v12 Changelog:

Released under the Creative Commons Attribution Share-Alike 3.0 License
<http://creativecommons.org/licenses/by-sa/3.0>
 Design by: R. Owens
 v12 modifications: Jim Lindblom

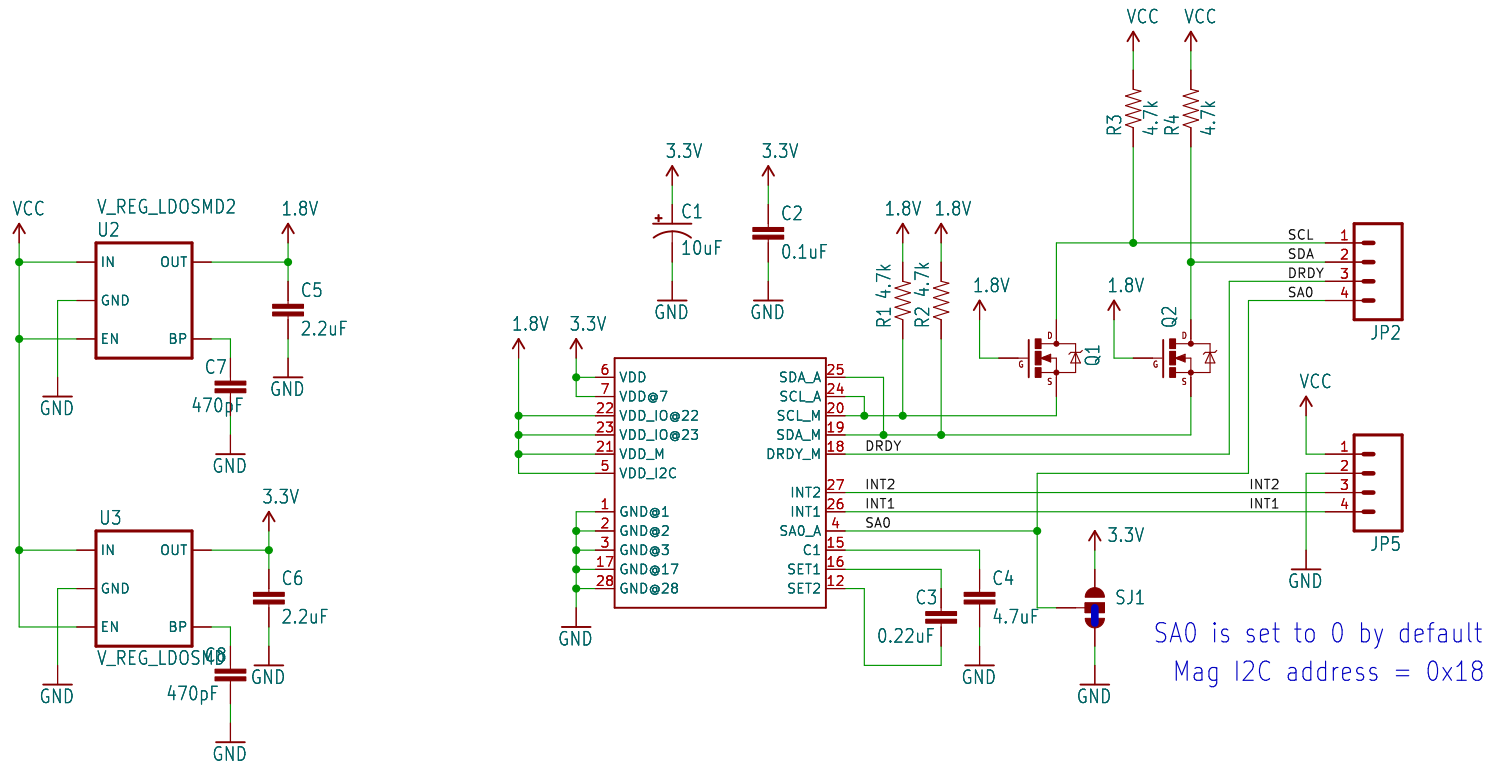
- *Added Q1, Q2, R3, R4, implemented level shifting on SCL/SDA
- * Changed all 0603 footprints to 0402
- * Added OSHW logo
